RECOMMENDATION MEETING

9025 46th Ave S
Seattle, WA 98118

#3036645-LU

5.0 MUP CYCLE 1 CORRECTION NOTICE & RESPONSE

Guidance Response 2c

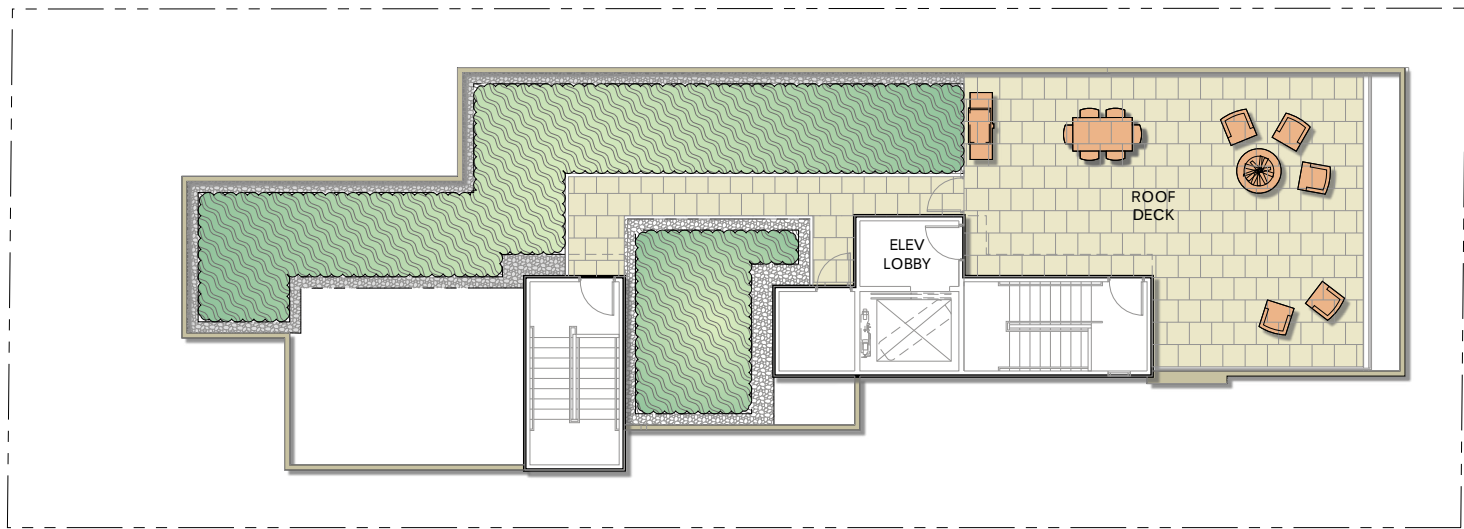
- a. Staff supports the proposed location of the roof deck at the street edge, which significantly reduces the potential for privacy impacts on adjacent properties. (CS2-D-5)
- b. In addition to complementing the neighborhood pattern, the raised entry also provides an opportunity for a stoop or porch-like amenity space that would encourage activation and interaction between neighbors. This concept could be fully realized by swapping the location of the lobby with the mail room (as described above) and providing some porosity in the form of operable windows or roll-up/accordion doors. (DC2-C-2, DC3-A, DC3-B, DC3-C-1)
- c. As the landscape plan is developed, consider how large screening elements (such as trees) can help integrate the proposal with the existing smaller-scale context. Indicate the container size of any new trees in the landscape plan. (DC2-C-2, DC4-D-3)

Large trees and shrubs reduce the perceived mass and help to integrate the building into the existing neighborhood and greenbelt. Many trees are needed to meet the Green Factor requirements. Trees are located along the perimeter of the site on the north and south property lines which will act as screening elements and help frame and visually soften the building in its context. Container sizes are noted on the planting schedule.

1 FACADE LENGTH DEPARTURE REQUEST DIAGRAM
1/8" = 1'-0"

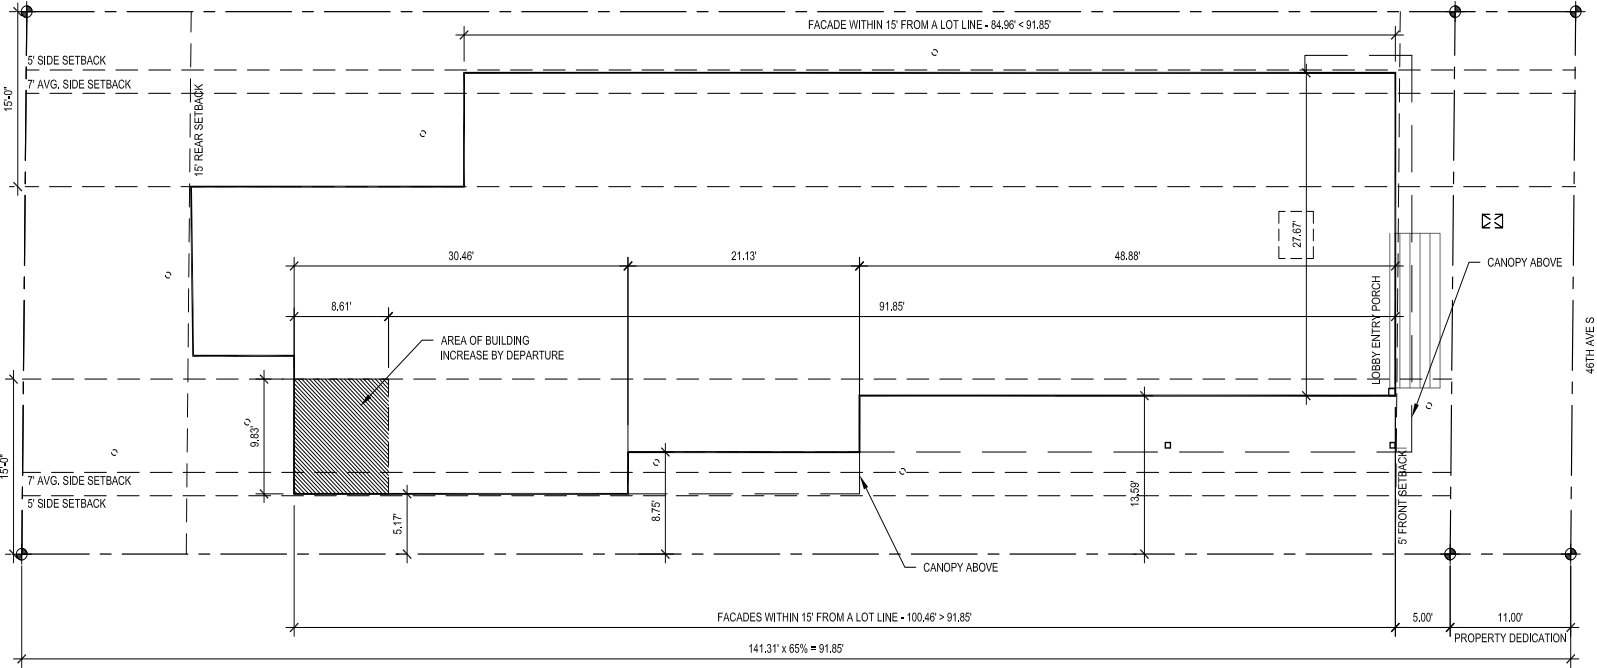
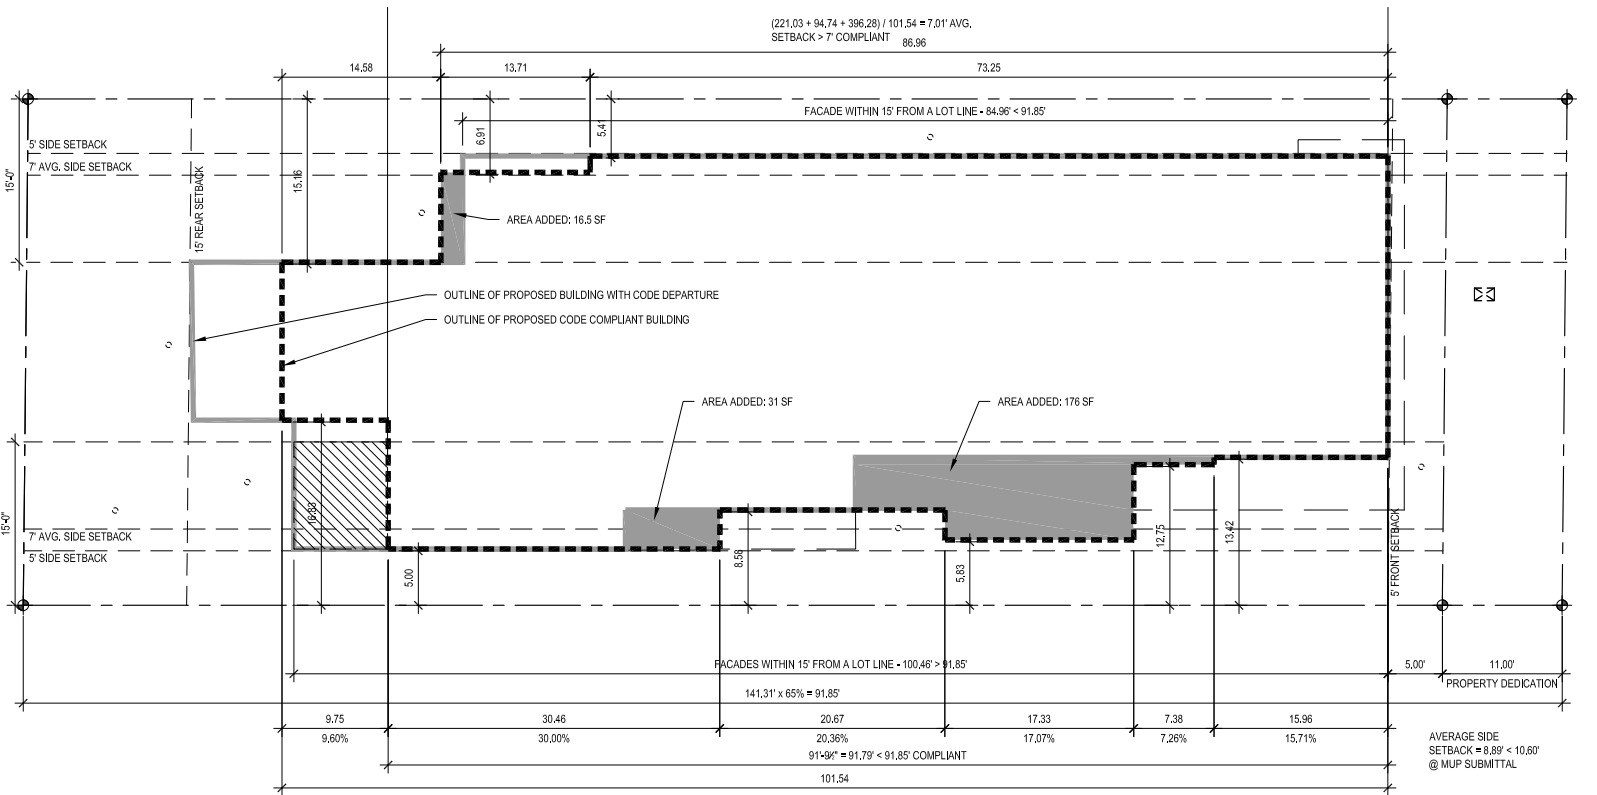
- 8. Staff does not support the two departure requests. The addition of the departures does not create a design that better meets the intent of the Seattle Design Guidelines. (CS2-D-5, PL2-B-3, DC2-A-2, DC2-B-2))

CODE CITATION:	23.45.527.B.1
CODE REQUIREMENT:	The maximum combined length of all portions of façades within 15 feet of a lot line that is neither a rear lot line nor a street or alley lot line shall not exceed 65 percent of the length of that lot line
CORRESPONDING DESIGN GUIDELINE:	CS2.C.2. Mid-Block Sites, CS2.D.1. Existing Development and Zoning, CS3.A Emphasizing Positive Neighborhood Attributes, PL2.A Accessibility, PL2.C.1. Locations and Coverage, PL3.A.2. Common Entries, PL4.B.3. Bike Connections, PL4.C.1. Influence on Project Design, DC2.A.2. Reducing Perceived Mass, DC2.C.1. Visual Depth and Interest
PROPOSED DESIGN DEPARTURE:	Allowed façade length: 141.31 side lot line length x 65% = 91.85'. Increase of total façade length within 15' of a side lot line by 8.61' to 100.46' or 71% of lot line length
RATIONALE:	The ADR guidance report supported the development of option 3, which included the departure request, that trades a narrower building profile and inviting entry sequence at the street for a slightly bulkier rear where the egress stair core is located. The supported ADR option is not possible without the departure. Reduces perceived mass. The building with the departure better meets the design guidelines by directly addressing guidance recommendation 1.d: the building is set back further from the south lot line to allow room for the ADA ramp placement. This allows enough run for the ramp to meet the necessary rise to the finish floor of the entry in one switchback. Without the departure additional ramp length is needed to extend around the front of the building, which would contradict the guidance recommendation, see detail 1D (CS3.A, DC2.A.2, DC2.C.1). The guidance report notes concern for the bulk and scale of the building multiple times. An equivalent building that is code-compliant is actually bulkier and extends further into both side setbacks than the proposed building. The departure request results in an additional area of 84.63 sf per floor plate located at the rear of the building on the south side. As noted in the diagram, a compliant building gets wider and extends out in multiple directions, adding a total area of 223.5 sf to each floor plate, or nearly 3x the area in the side setback. In addition, the building as designed with the departure results in no portion exceeding the minimum 5' side setback and results in an average side setback 10.60 feet on the south side. Thus the building is actually less bulky than a compliant building, fitting better into a neighborhood transitioning from low density to high density, see plan diagrams & detail 1B & 1C (CS2.C.2, CS2.D.1). Furthermore, the narrow street-facing façade created by the departure is no wider than the front-most façade of either neighboring house by 8", helping the building fit in with the current context, see detail 1E (CS3.A.1, CS3.A.4). The owners brought up concerns about ease of access to the building and creating a pleasant entry sequence, which is also mentioned in the guidance report recommendations 1.d, 1.g, 1.h, & 2.b. As noted above a compliant building requires the ADA ramp to extend around the front of the building. The space needed for such an additional ramp run eliminates the stoop and results in an entry sequence that is convoluted and cumbersome, as seen in the diagram 1D. The departure allows a linear pathway for residents from street, to stoop, to vestibule, to lobby, to corridor. The resulting entry sequence allows for direct visual connection to the street, more street activation, and ease of movement through the building, resulting in longevity for the structure.
